SERVICE BULLETIN

Service Bulletin No.: DAC1-74-01 Rev 0

Title: Ignition Harness Routing

- 1. ATA Code:** 7420
- 2. Effectivity:** All DA20-C1 Aircraft.
- 3. General:** This Service Bulletin addresses a revision of the ignition harness wiring to improve cold weather starting. The revision consists of switching the spark plug leads from the top to the bottom.

Figure 1
Left Side View of Engine

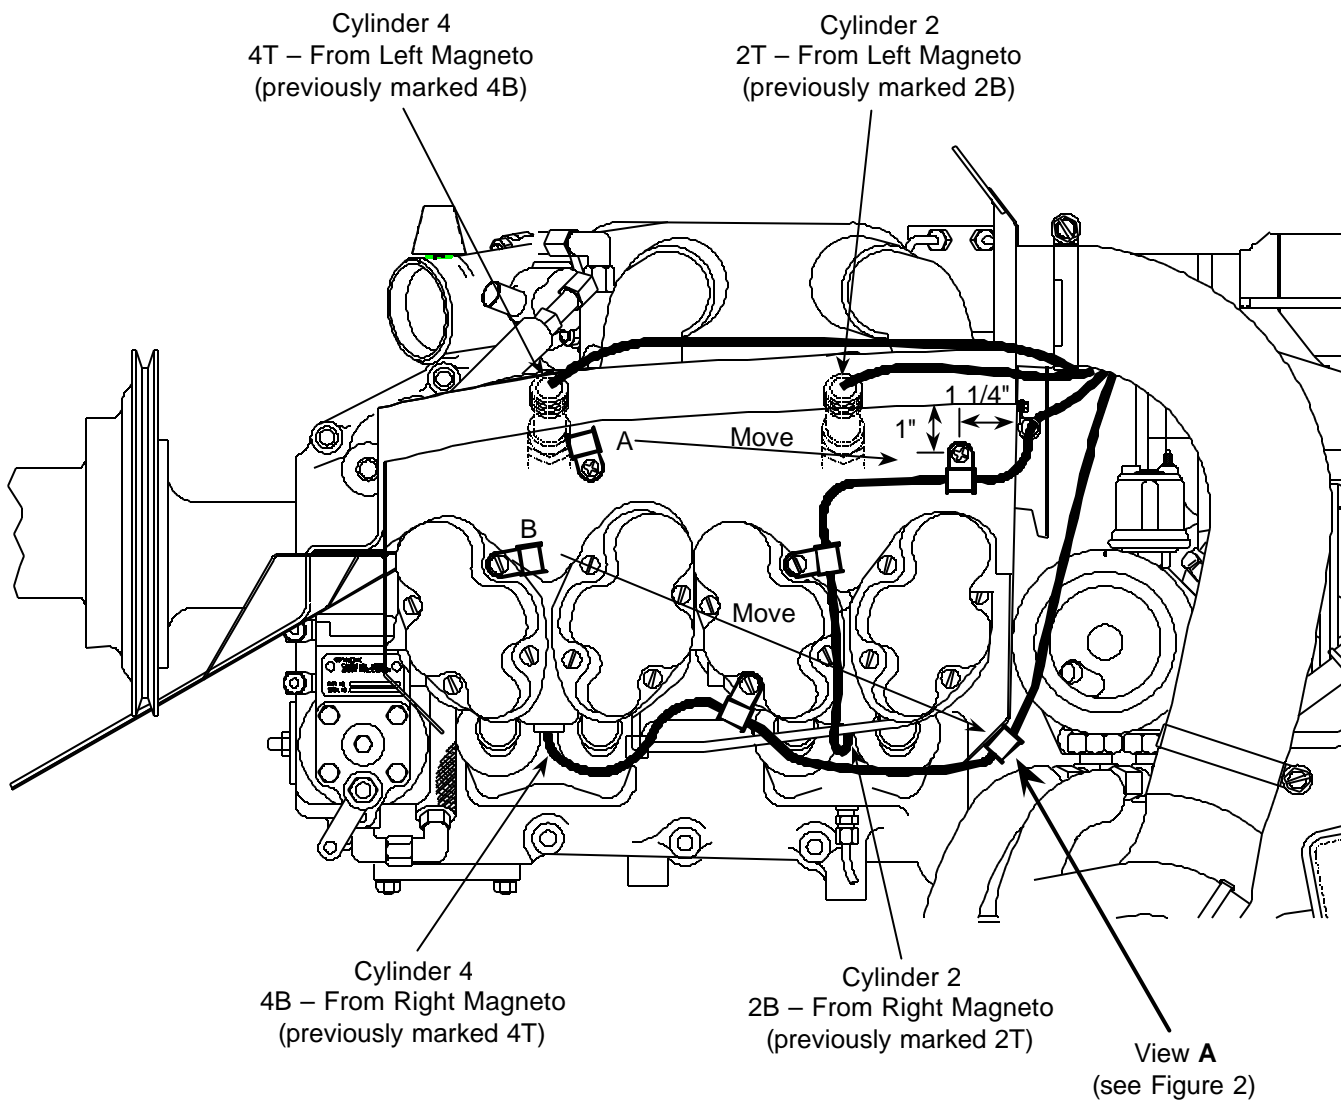
- 10. Accomplishment Instructions:**
 - 10.1** Remove the cable ties from the harness behind the engine (Note the locations).
 - 10.2** Drill a #10 diameter hole 1¼" forward and 1" down from the upper aft corner of the right baffle (Figure 1).

- 10.3** Remove the cable clamp from location A and move it to the new location (Figure 1). The hole at location A may be sealed with suitable hardware or left open (cooling air leakage is negligible).

- 10.8** Reroute the harness as shown in Figure 1 and 3.
 - 10.9** Mark the ignition harness B nuts in accordance with SSI 99-4.
 - 10.10** Make a log book entry stating that this Service Bulletin has been incorporated.

Figure 2
View A from Figure 1

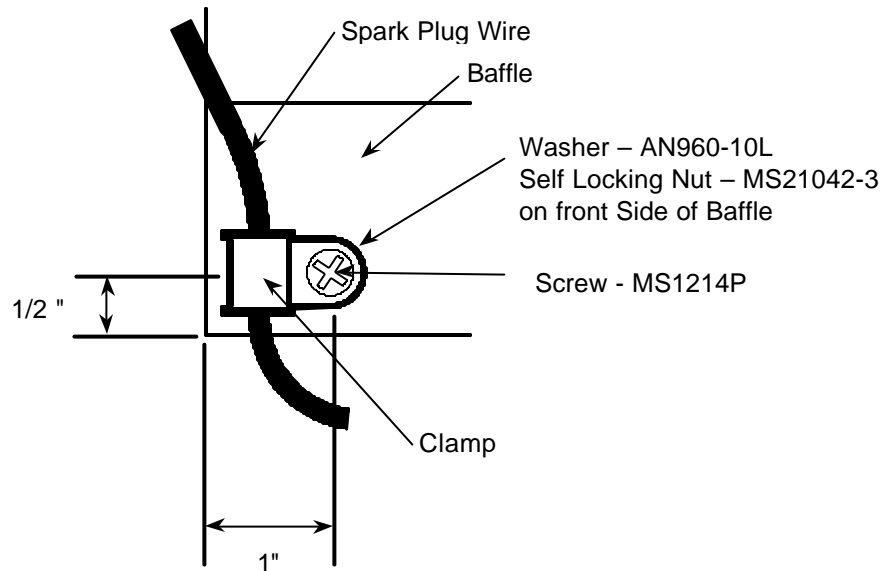
- 10.4** Drill a #10 diameter hole 1" inboard and ½" up from lower left corner of the aft baffle (Figure 2).
 - 10.5** Remove the cable clamp from location B and move it to the new location (Figure 1). Use suitable hardware (Figure 2).
